VEHICLE SAFETY DEFECT SERVICE BULLETIN

Recall Campaign No. 04V325000

Re: Recall: ABS Dash Lights

Recall 04V325000 R04028 Dash ABS Lights

04R701

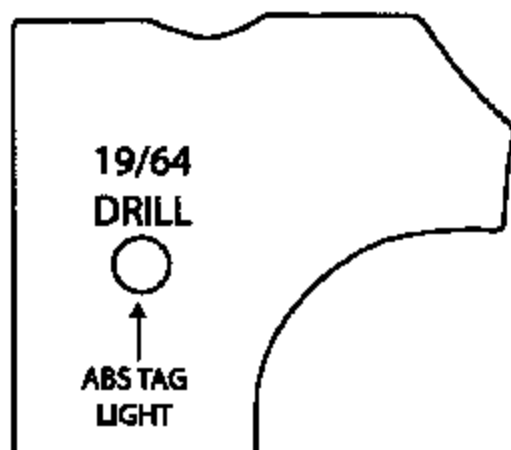
1. Locate the 3 pin plug on relay circuit board # 2 on the right side of the front electrical bay (Figure 2).
2. Add the 14ga brown wire (supplied) to pin position # 2 and route the wire up under the shifter panel.
3. Continue routing the brown wire to the dash panel and connect it to the ABS light.
4. Locate the 4 pin M-55 plug under the shifter panel.
5. Locate the yellow/green wire in pin position 3.
6. Splice in a new 14ga yellow wire.
7. Route the new yellow wire to the dash panel and connect it to the ABS light.
8. Locate the 4 pin M-55 plug under the shifter panel.
9. Locate the black wire and the white wire in pin positions 1 & 2.

04R702

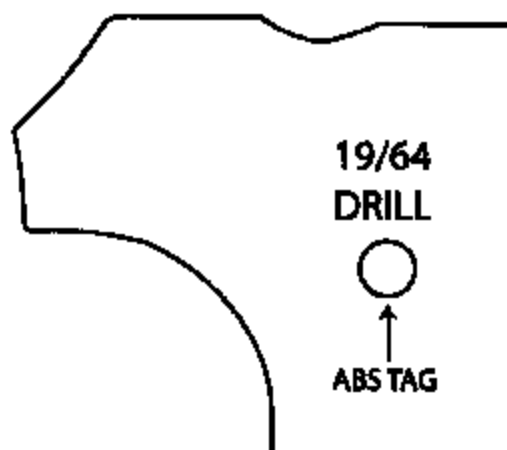
1. Remove the access cover from the top of the dash.
2. Cut out the hole templates located at the bottom of the repair instructions, located on page 3.
3. Position the templates with the large radius over the air gauge and the small radius in line with the light array and tape into place (Figure 1).
4. Use a 19/64" drill bit and drill a hole in the dash through the template.
5. Install the ABS TAG light on the left side of the dash.
6. Install the ABS light on the right side of the dash.
7. Install the new 2 pin plugs on the wires from the lights.
